Intel[®] Quark[™] SoC X1000

Specification Update

June 2014

12.7.3.1 ECC Scrubber Configuration Register (P_CFG_50) — Offset 50h

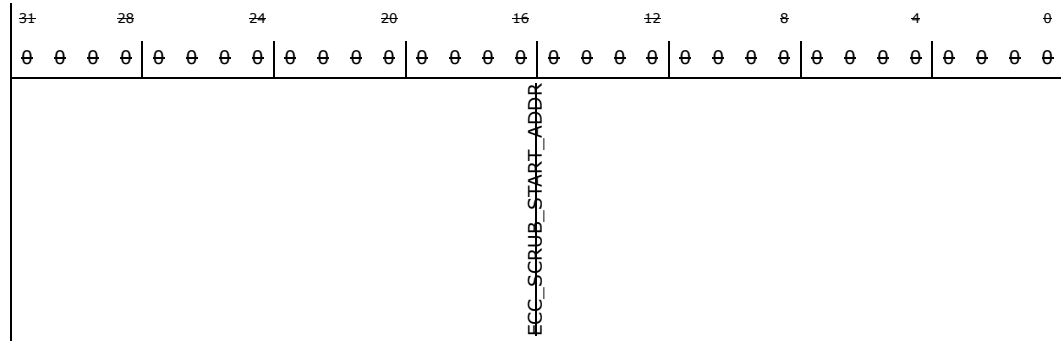
1. ECC Scrubbing Has Been Defeatured and is No Longer Supported on the Intel® Quark™ SoC X1000

Old Text: ECC Scrubber Registers (Offsets 50h, 76h, 77h, 7Ch) have been removed.

New Text: Section 12.3.1 ECC Scrubbing has been removed.

~~12.6.2.1 SPI DMA Count Register (SPI_DMA_CNT_IOSF) — Offset 0h~~

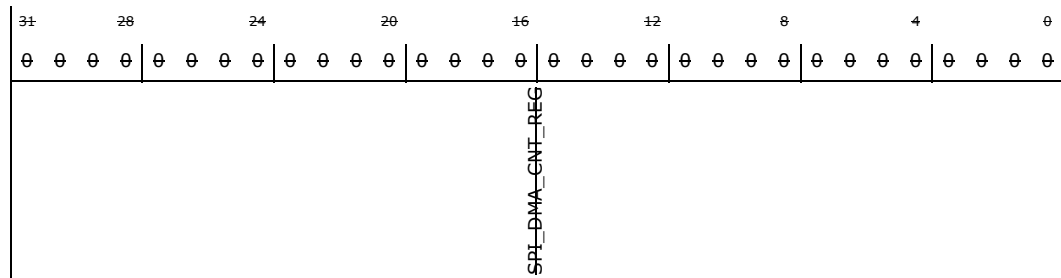
2. Remote Management Unit DMA via IOSF Primary is No Longer Supported on the Intel® Quark™ SoC X1000

Issue: The Intel® Quark™ SoC X1000 uses only the sideband option for setting up a DMA transfer.

New Text: Section 12.6.2 has been removed.
